CALIFORNIA COASTAL COMMISSION

COASTAL DEVELOPMENT PERMIT APPLICATION

Application number3-01-111, Pelican Point Riverwall

Project descriptionInstall a driven sheet-pile metal wall along roughly 715 linear feet of the Pajaro River and Watsonville Slough sides of the Pelican Point condominium portion of the Pajaro Dunes residential development.

RIVER/SLOUGH
SIDE OF
SHEETPILE WALL

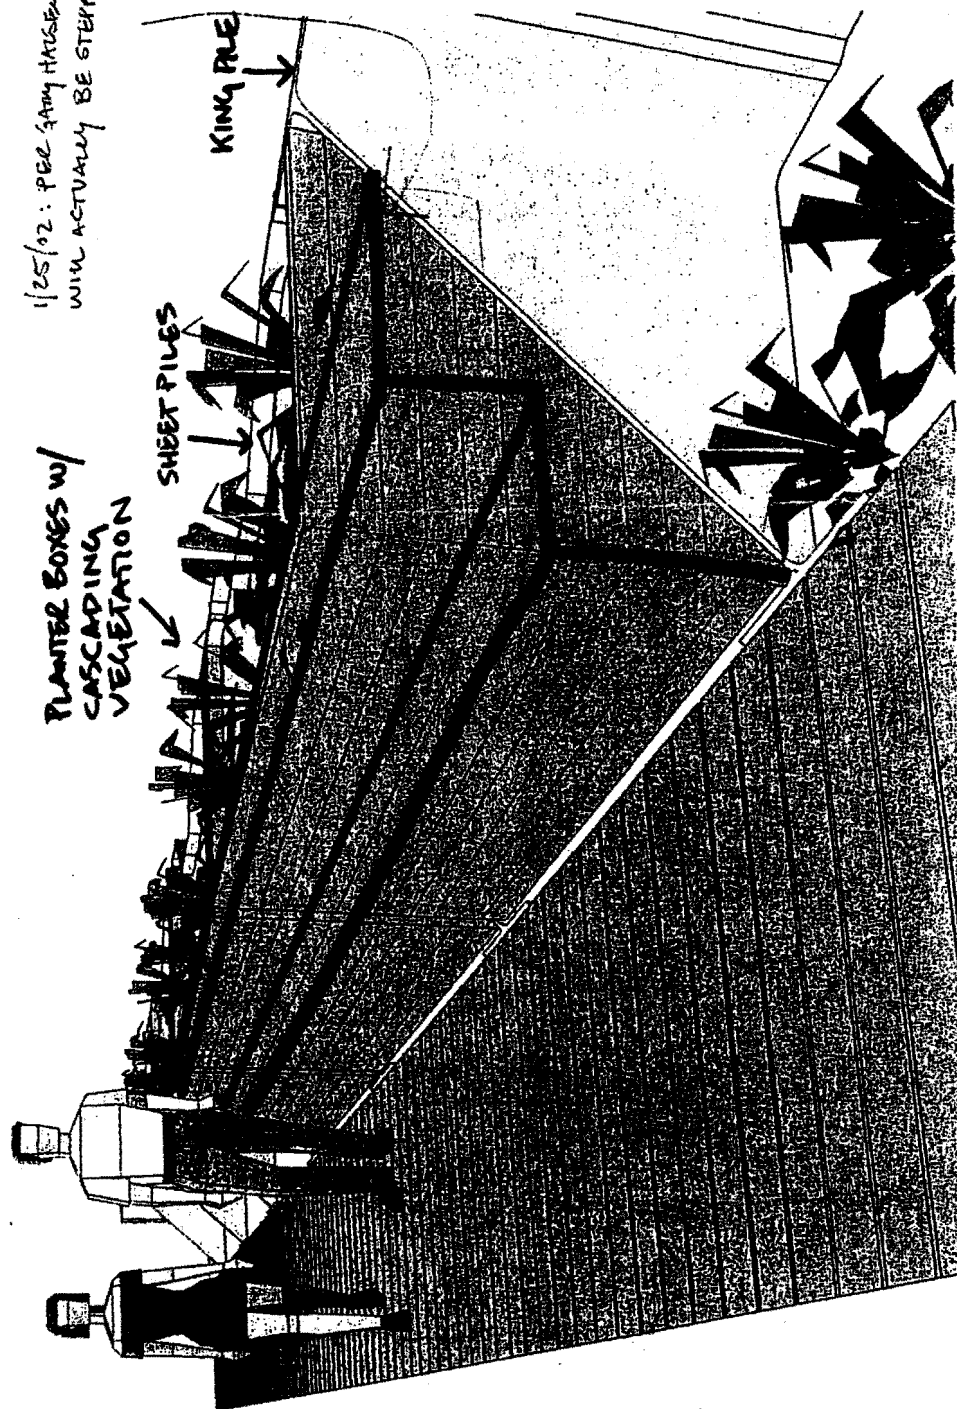
1/25/02: PER GARY HANSEN,
WILL ACTUALLY BE STEPPED

RESTORATION AREA DETAIL

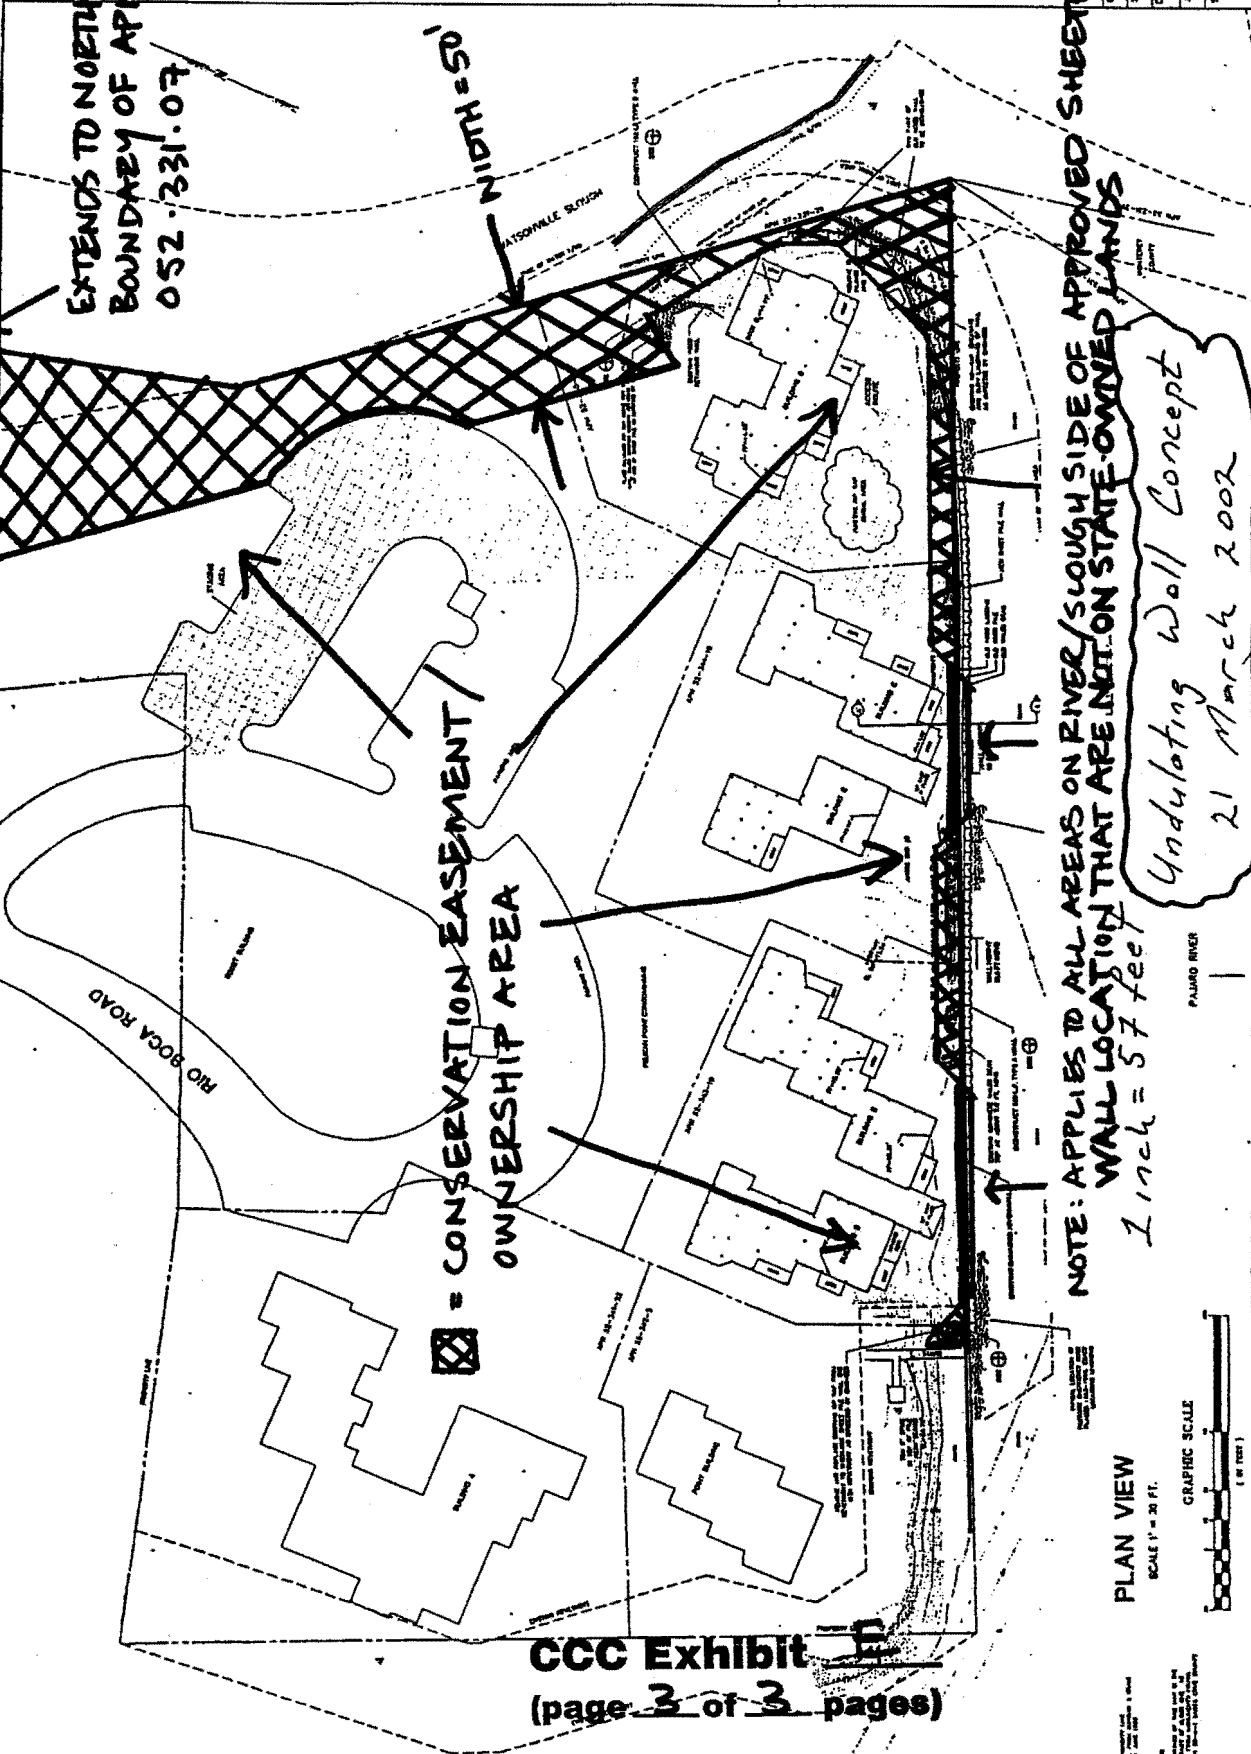
All areas on the river/slough side of the sheetpile wall within the construction zone must be restored to provide high quality habitat (see restoration area detail in exhibit E). The Applicant will need to submit a revised restoration plan for this purpose consistent with the Commission's generally accepted parameters for such plans. See special condition 2.

The area north of the project site on the Applicant's property between the waters of Watsonville Slough and the paved roadway area (i.e., the general area for which the Applicant has proposed a conservation easement) must be restored to provide high quality slough habitat. The revised restoration plan must be extended to cover this area as well (see restoration area detail in exhibit E). See special condition 2.

- (a) **Expanded Restoration Area Adjacent to Sheetpile Wall.** The Revised Restoration Plan shall provide for high quality dune and slough restoration of all areas located on the Pajaro River/Watsonville Slough side of the revised sheetpile wall location (identified in the approved Revised Sheetpile Wall Plans per special condition 1 above); see page 2 of exhibit E for graphic depiction of this area.

- (b) **Expanded Restoration Area Adjacent to Watsonville Slough.** The Revised Restoration Plan shall provide for high quality wetland/upland restoration and habitat enhancement in the area north of the sheetpile wall as shown on page 2 of exhibit E. All invasive non-natives shall be removed from this area, and significant trees shall be retained.
